**IDO - 502 - PRODUCT CHANGE NOTICE - IN-WALL
GEAR RACKS SWITCHING TO STANDARD**

Product Change Notice - In-wall® Slide-out gear racks switching to all standard

Inverted Gear Rack - currently offered as an option

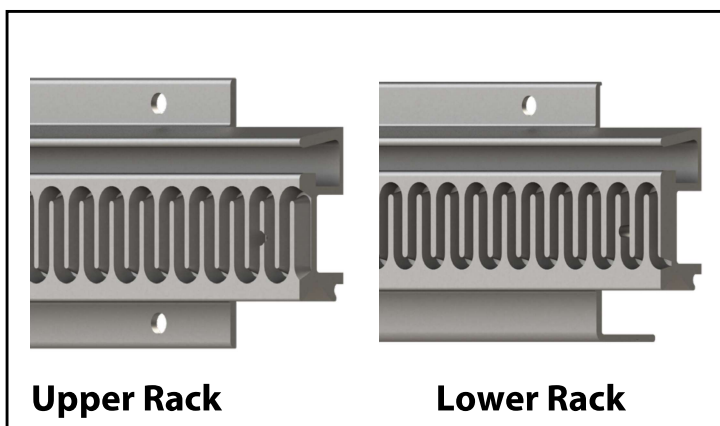
Beginning Jan.1, 2022, Lippert and its vendors will be focusing all efforts on producing only the original standard gear rack version of the In-Wall product. The change will allow all our vendors' efforts to be laser focused on one version of the product. Consolidating to one style of gear rack combines efforts to raise the overall capacity for continued growth in product volume.

There will be no changes needed in construction or installation for the OEM (or for service) with the change to all standard gear racks, if instructional guidelines are being followed.

Based on thorough review of field data, the water management performance of both system styles has proven to be functionally equivalent, so there are no advantages to offering both gear rack styles.

- 1. Will a new part number be required?** Yes, new part numbers will be issued.
- 2. Does the price change for the item?** No, there is no price change associated with the switch.
- 3. Is the new part wholly interchangeable with the previous version of the part?** Yes, as a complete mechanism for replacement . No, not as individual parts. Internal components will be different.
- 4. Does the customer need to replace inventory?** No, the change will be made on a running basis, starting on or around Jan. 1, 2022.
